ZONING & PLATTING COMMISSION
SITE PLAN REVISION & VARIANCE REQUEST REVIEW SHEET

CASE NUMBER: C14-83-224(R1)

PROJECT NAME: Pinnacle at Great Hills

VARIANCE REQUEST: To allow driveway construction on a slope greater than 25 percent to areas of slope not less than 25 percent. Lake Austin Watershed Ordinance Section 29-55.3(a)(1).

Area of driveway construction on slopes just outside of the power line easement

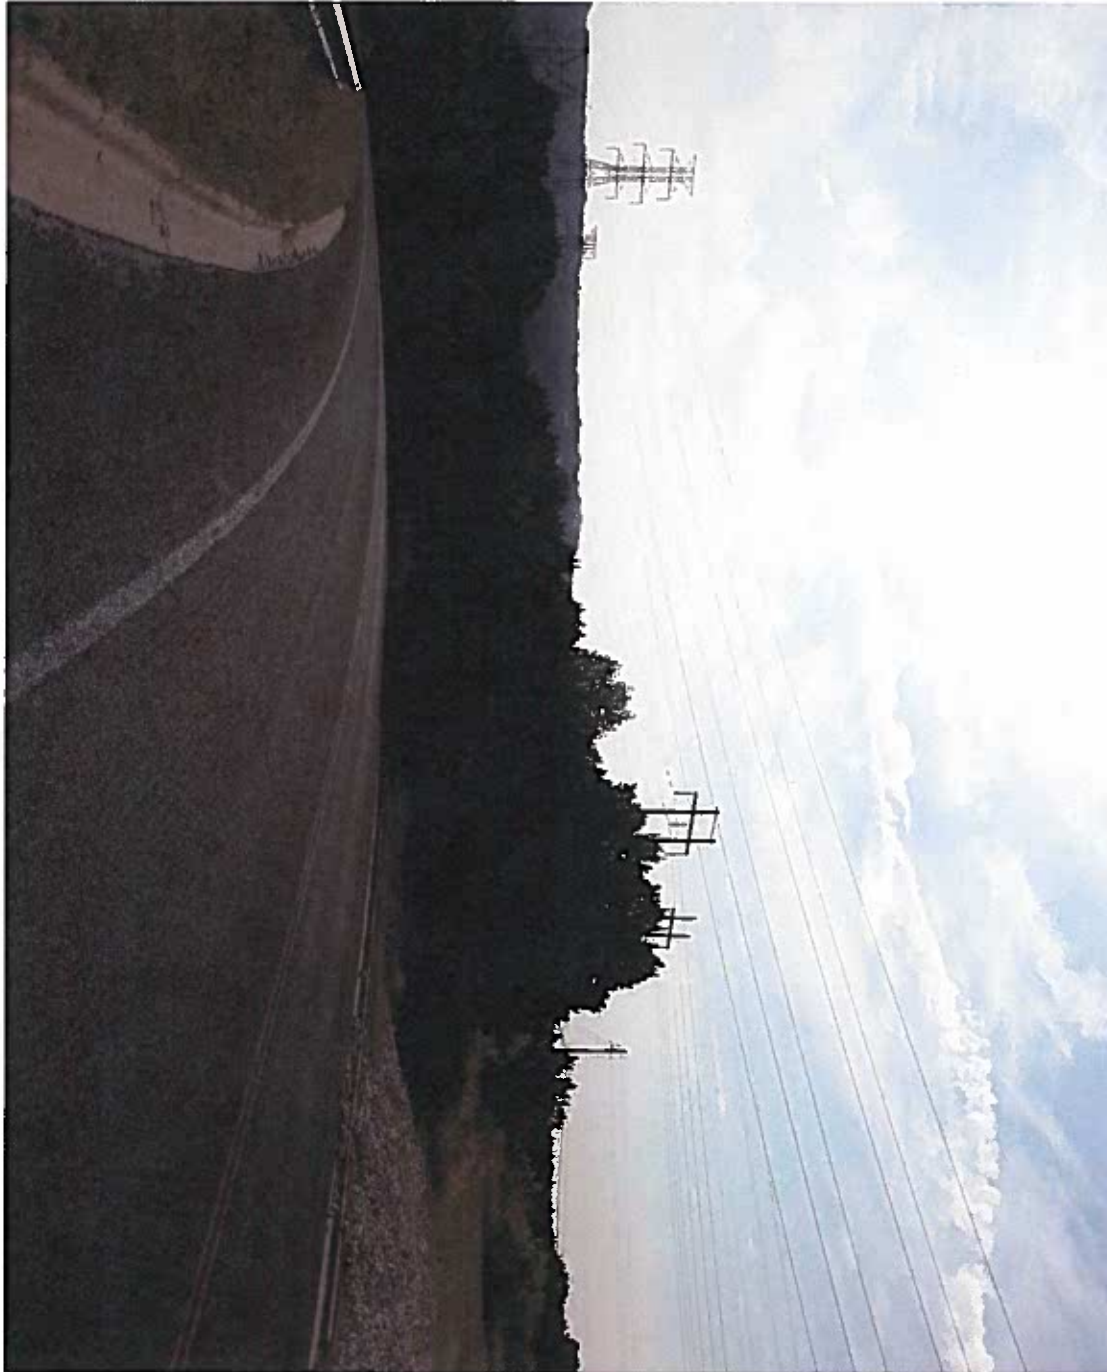
The project proposes approximately 1,086 square feet of driveways on slopes greater than 25%. This equates to approximately 0.7% of the overall 25% and greater slope category area and will allow reasonable use while avoiding deprivation of privilege already granted to another similarly timed development.

The variance request for driveways on slopes greater than 25% requires no cut or fill greater than four feet. It will allow for a finished driveway grade not to exceed 14% and because drive access will be from above on the slopes will leave a more natural finished grade that will not require structural stabilization.

Site Plan
C14-03-224(R1)

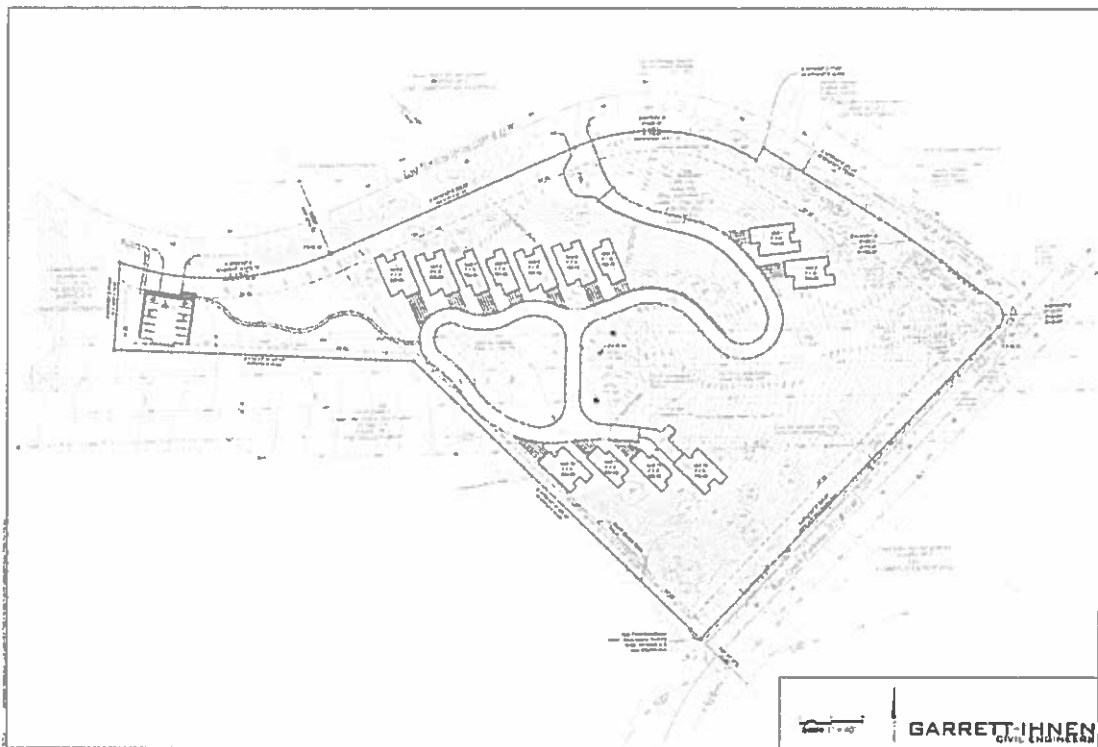
1. Reduces the area of construction of driveways on slopes greater than 25% from the Council approved plan from 9,270 sf to only 1,085 sf (88% reduction);
2. The variance request impacts less than 0.7% of the total site slopes greater than 25%.
3. Reduces the number of units accessed by driveway over slopes greater than 25% from 9 units to 7 units;
4. Reduces area cut and fill in excess of 4' to zero;
5. Reduces the overall impervious cover from 66,492 square feet to 59,692 square feet;
6. Reduces the number of driveways from eight to two;

As previously stated, the replacement site plan will provide an 88% reduction of construction on slopes greater than 25% from the City Council approved site plan for C14-83-224. Furthermore, the previous City Council approved site plan for C14-83-224 actually requires cuts and fills greater than four (4') feet whereas this replacement site plan requires no cuts and fills greater than four (4') feet. Therefore, we believe this variance request for crossing slopes greater than 25% is the minimum departure from site development standards necessary to avoid such deprivation of privileges enjoyed by such other property and to facilitate a reasonable use. Furthermore, by accessing the dwelling units from above the ridge rather than below the ridge avoids any cut and fill variances and does not create significant probabilities of harmful environmental consequences.
